AMENDMENTS TO THE DRAWINGS:

P/61741

FIG.1

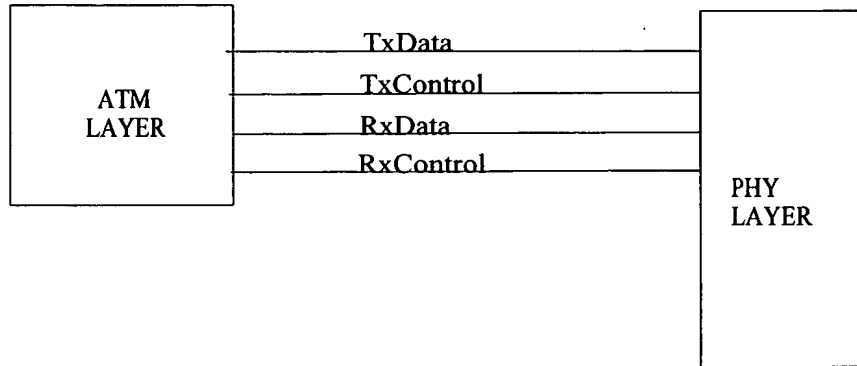
Please add the term “*Prior Art*” to Figs. 1-4.

PRIOR
ART

FIG. 2

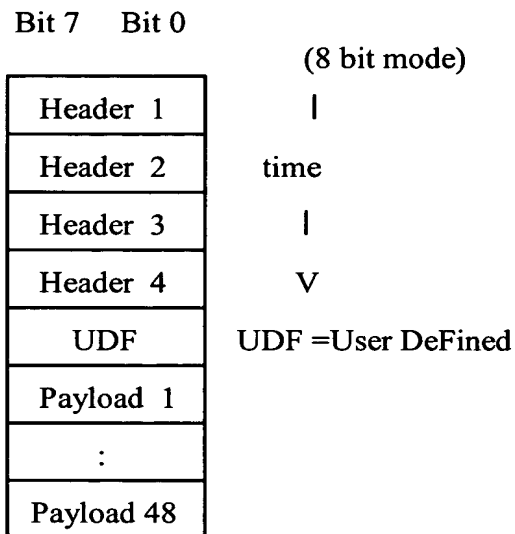
PRIOR ART
